RHODE ISLAND DEPARTMENT OF TRANSPORTATION

Bridge Group 54A -Kingston Rd Bridge

NOTICE TO PROSPECTIVE BIDDERS

ADDENDUM NO. 2 Prospective bidders and all concerned are hereby notified of the following changes in the Plans, Specifications, Proposal and Distribution of Quantities for this contract. These changes shall be incorporated in the Plans, Specifications, Proposal and Distribution of Quantities, and shall become an integral part of the Contract Documents.

**NORTH ABUTMENT
PLAN AND ELEVATION**

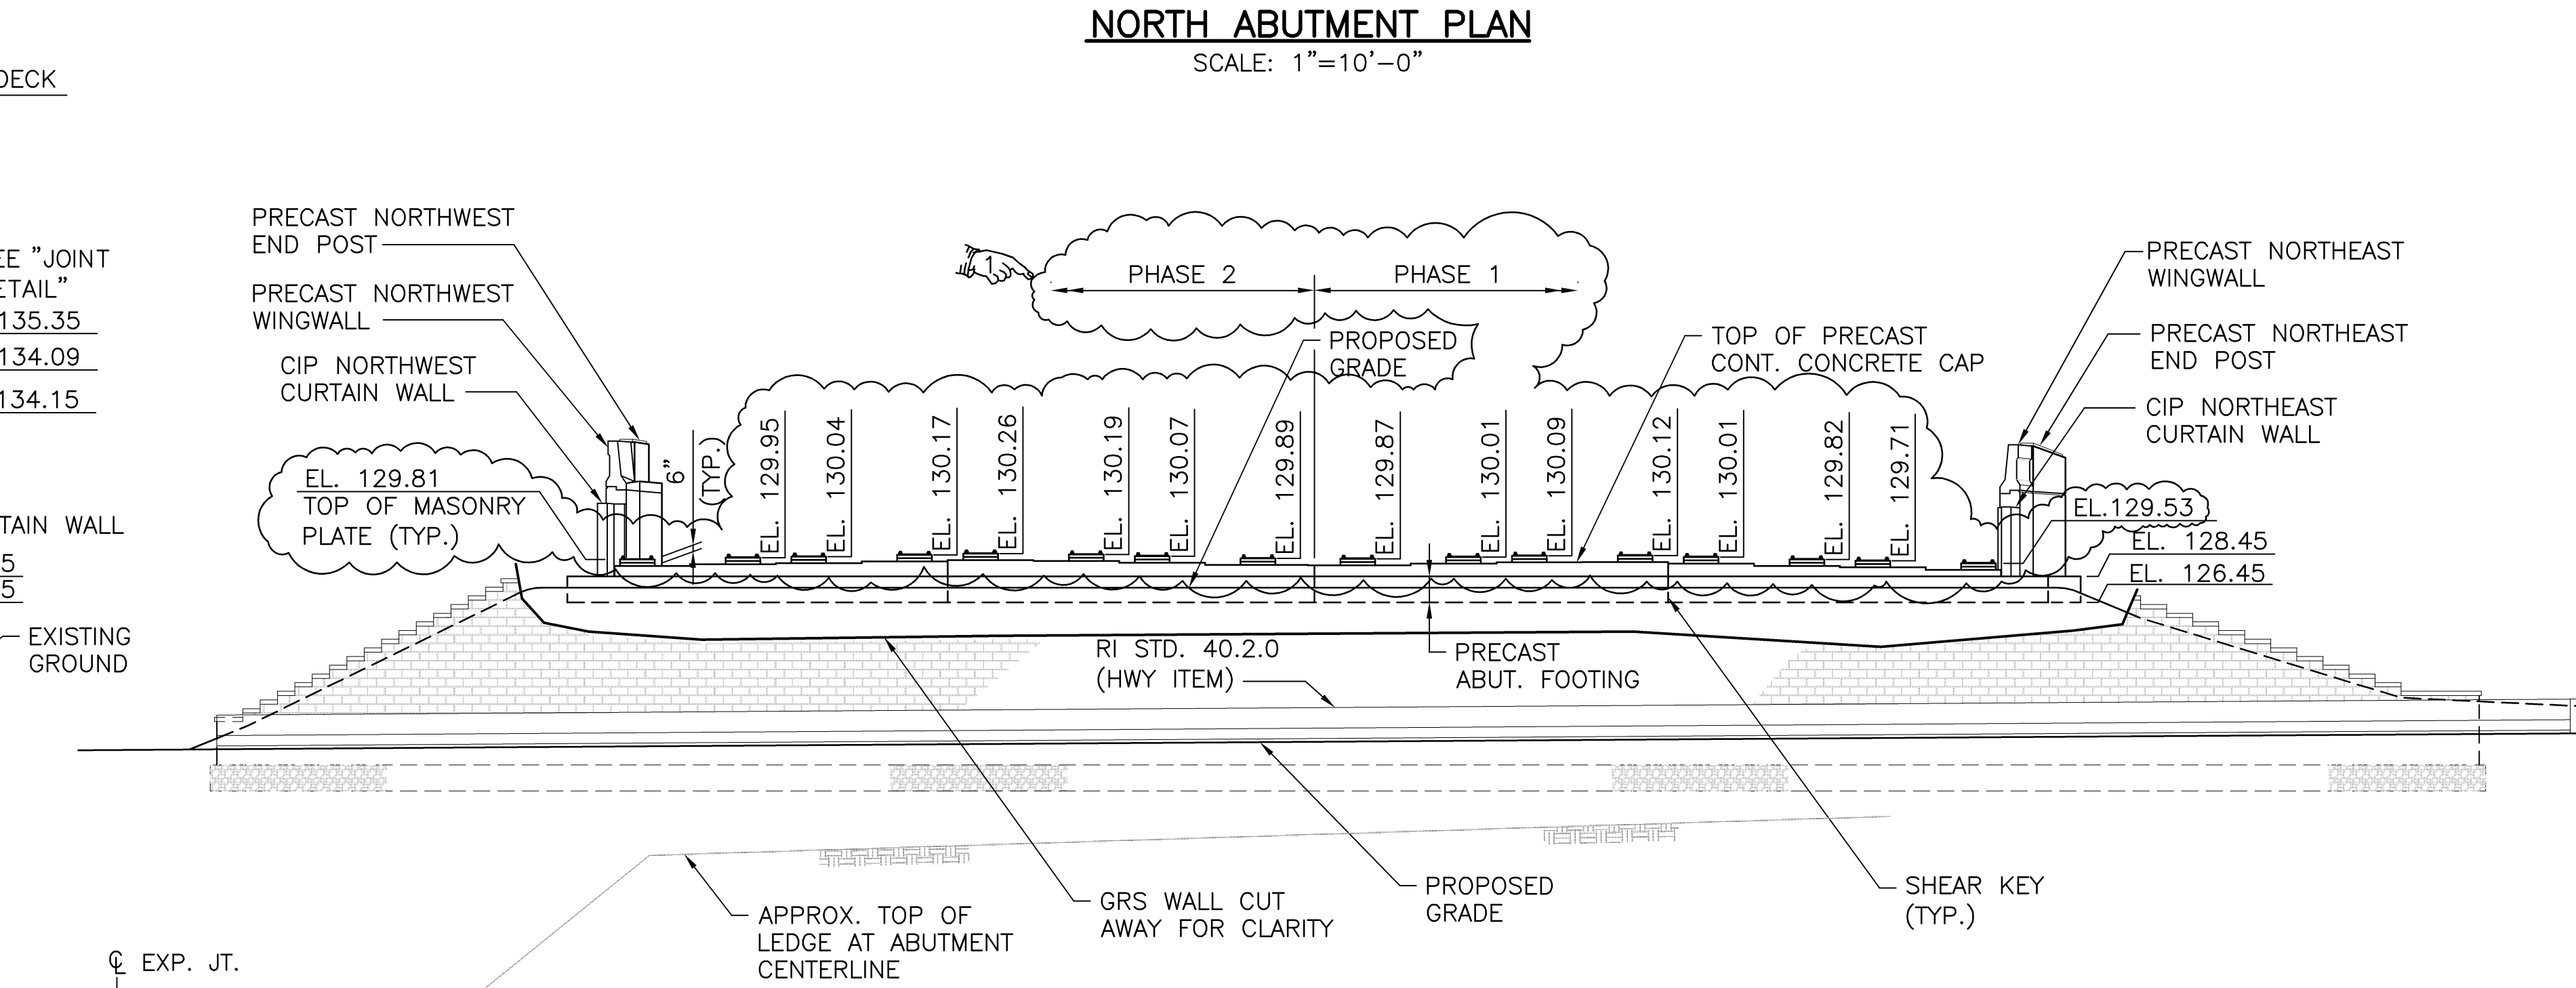
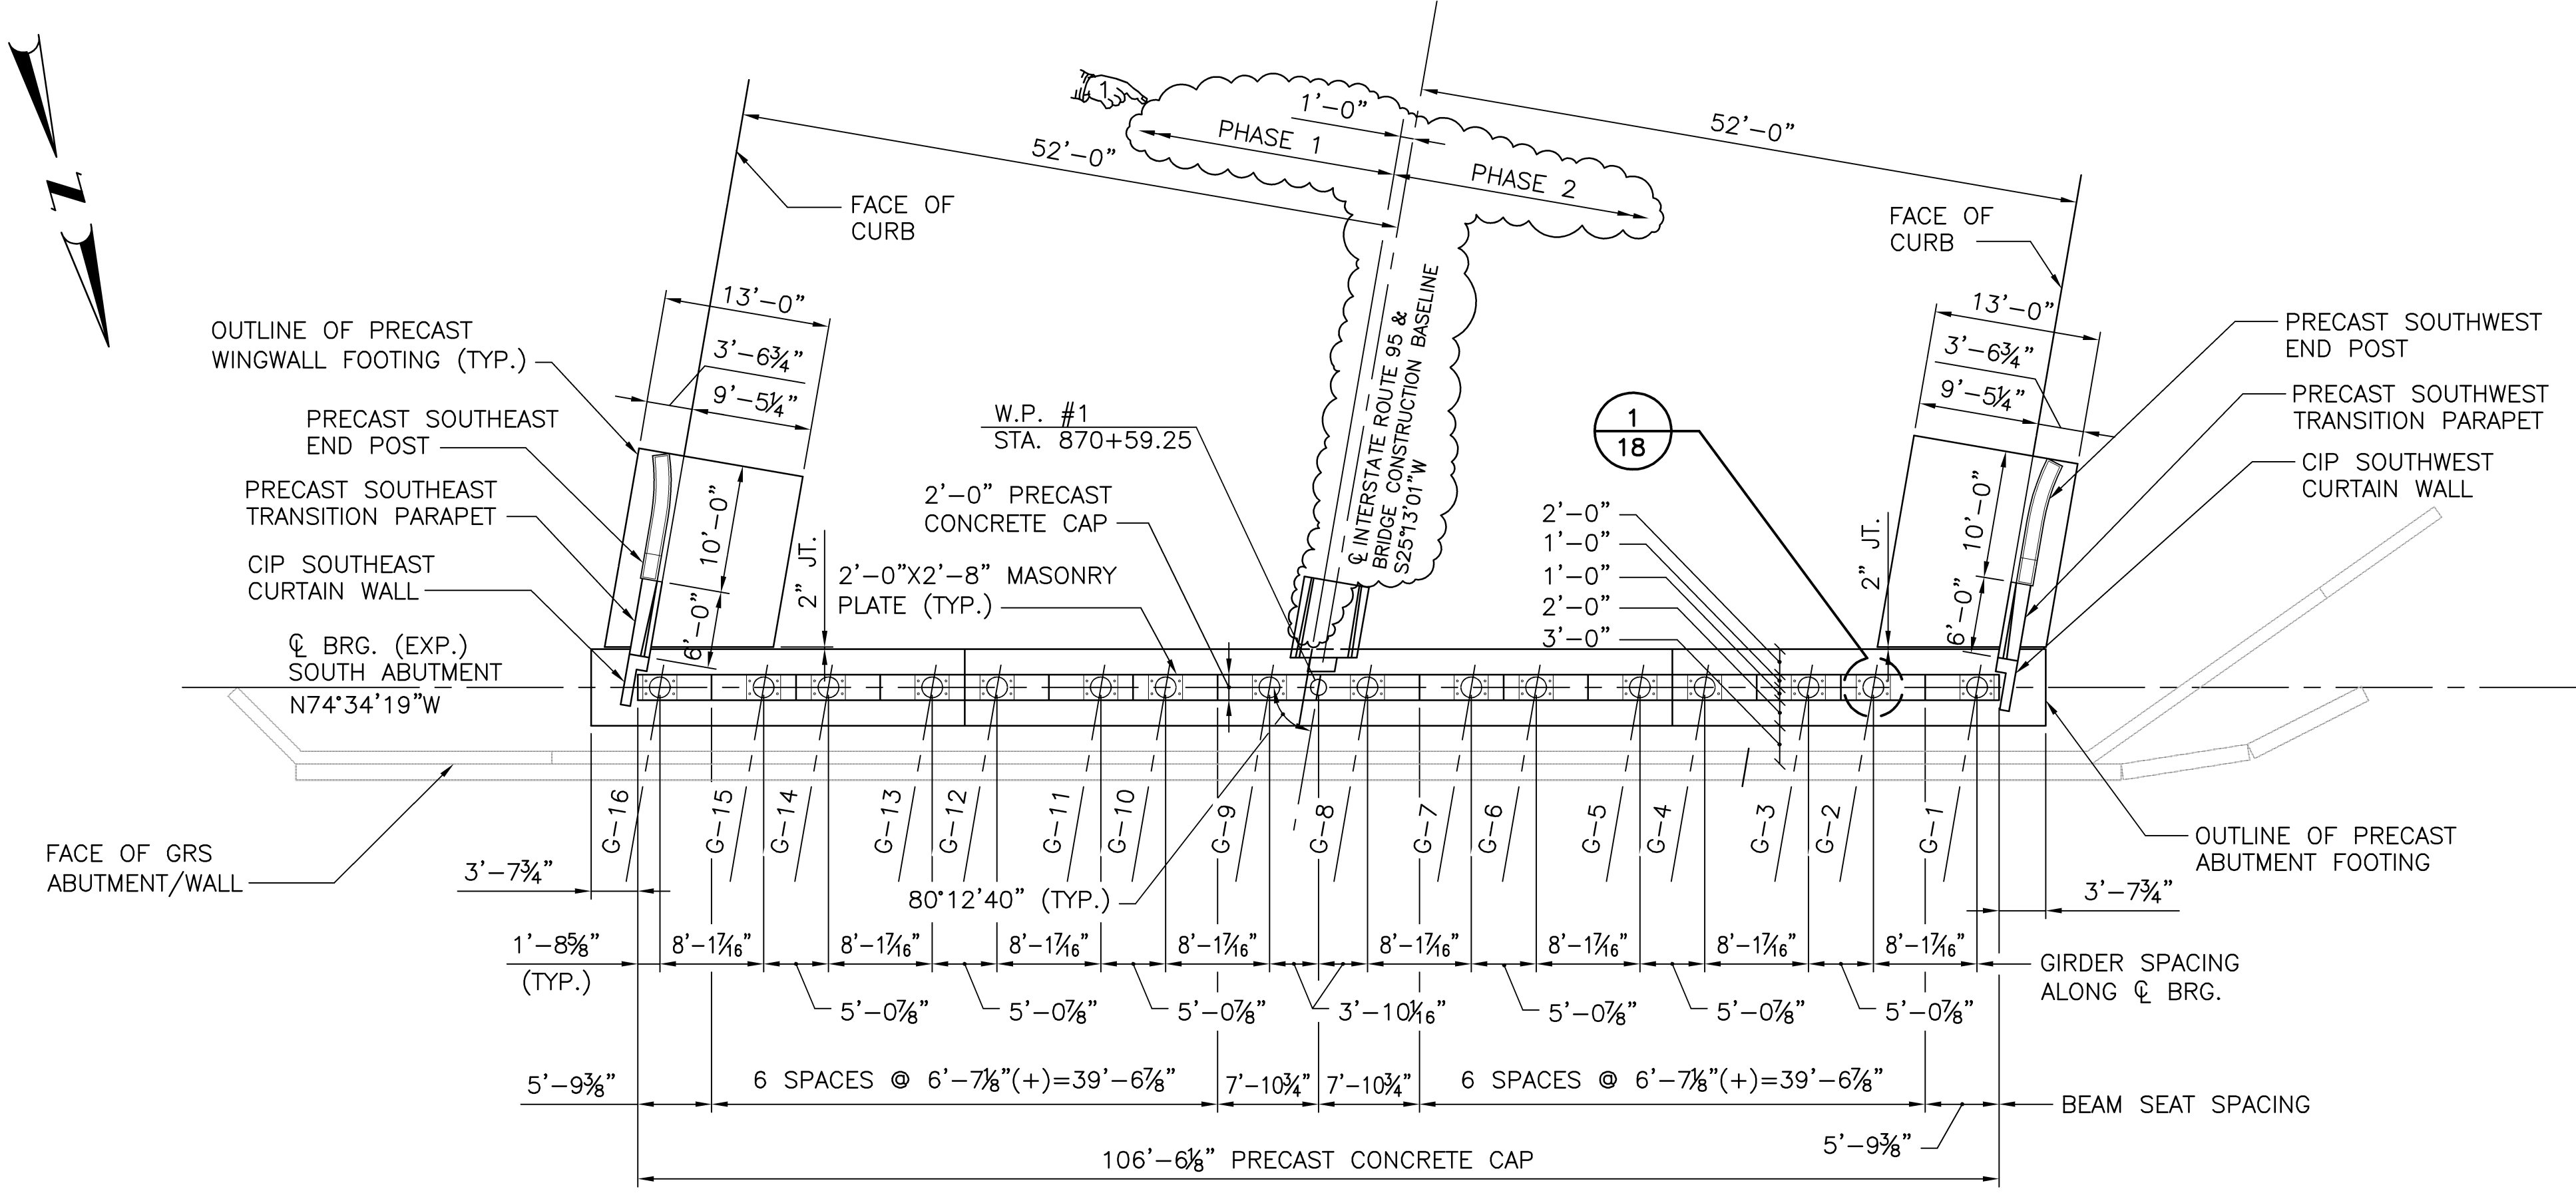
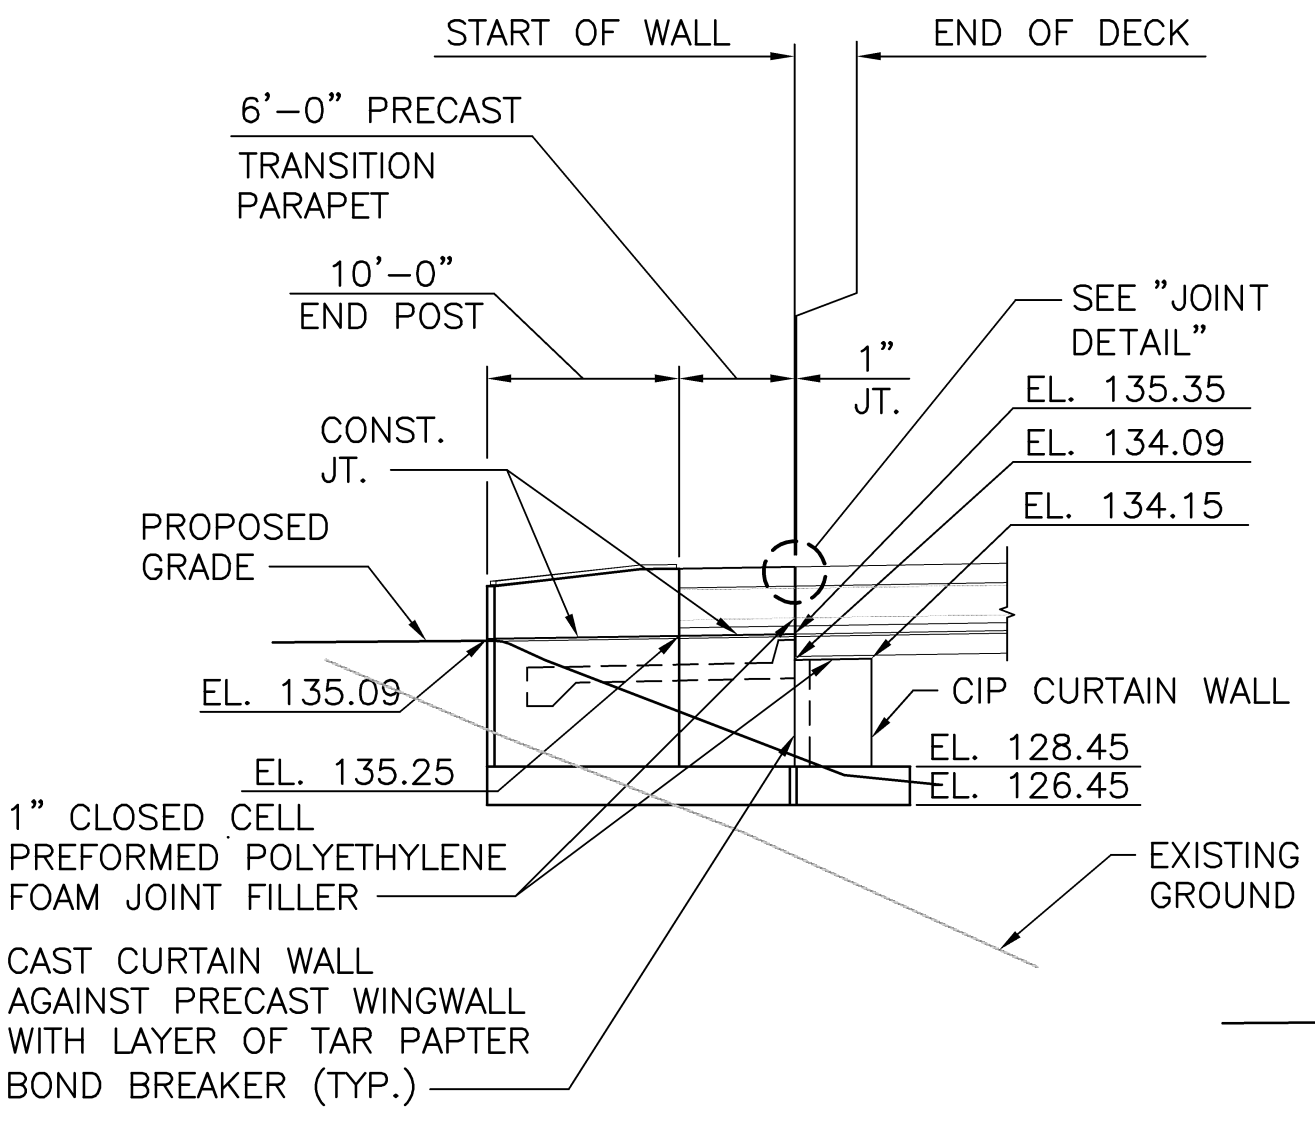
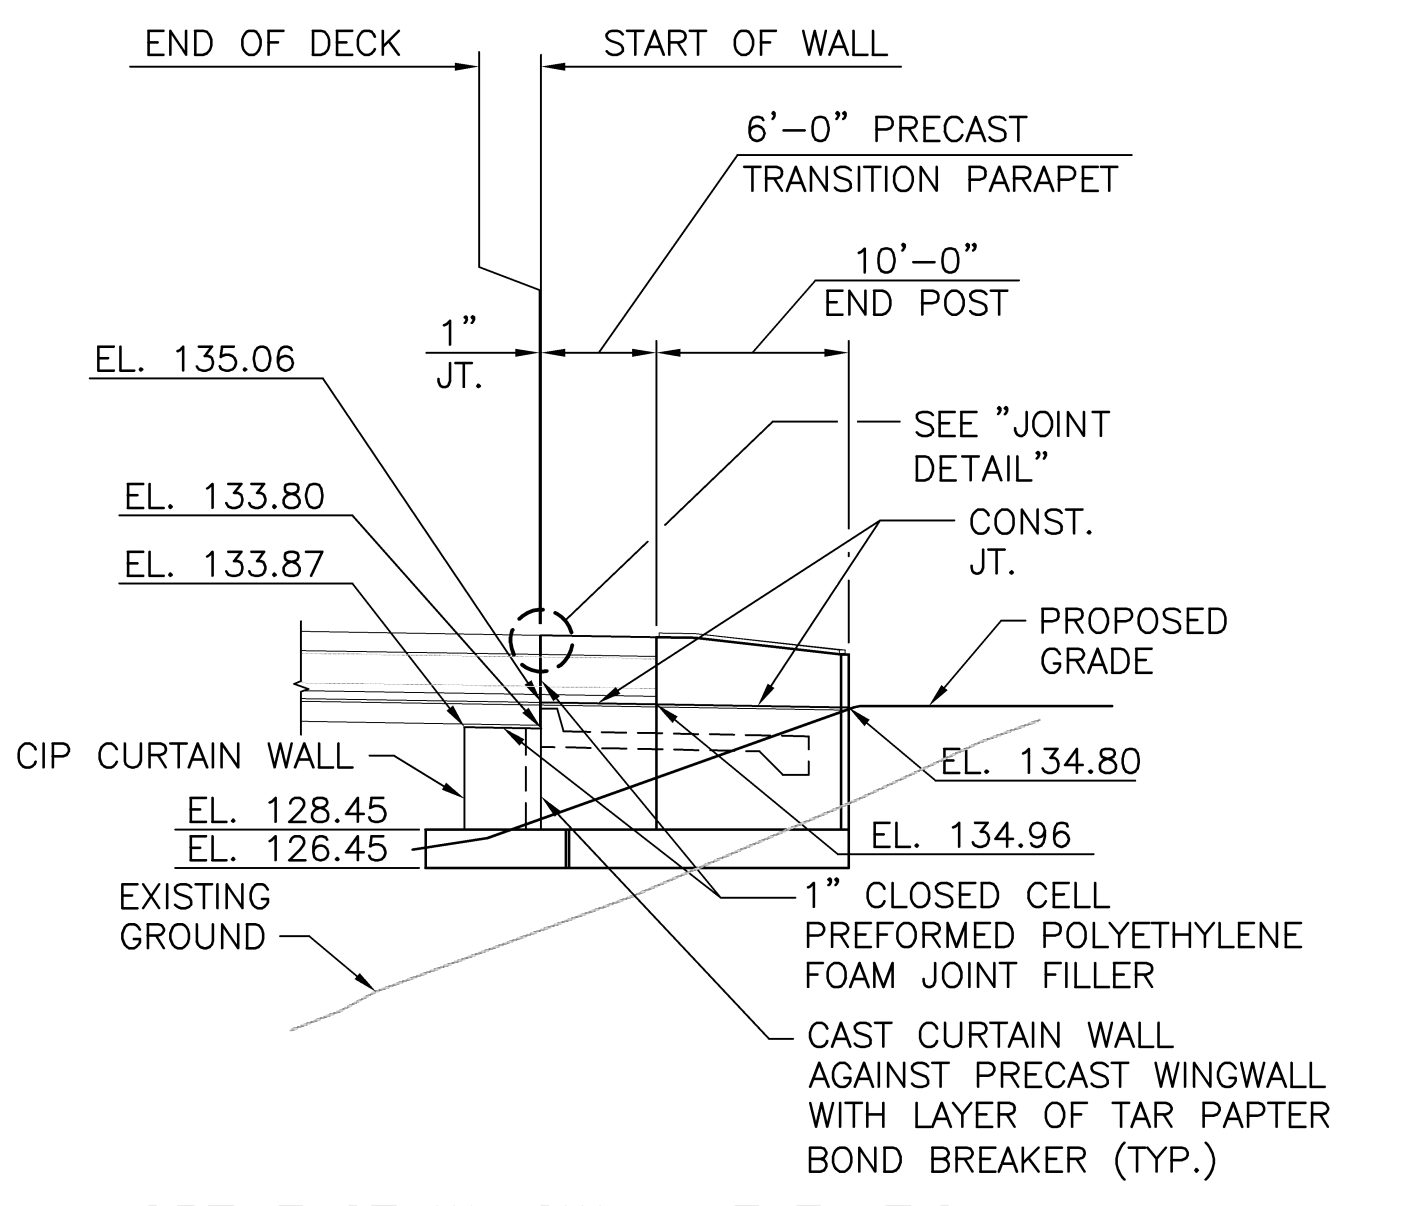
4. Volume 2 Plan Sheet No. 18 - North Abutment Plan & Elevation
Remove Volume 2 Sheet No. 18 in its entirety and replace it with revised Sheet No. 18 (R-1) attached to this Addendum No. 2. North Abutment Plan & Elevation sheet has been revised.
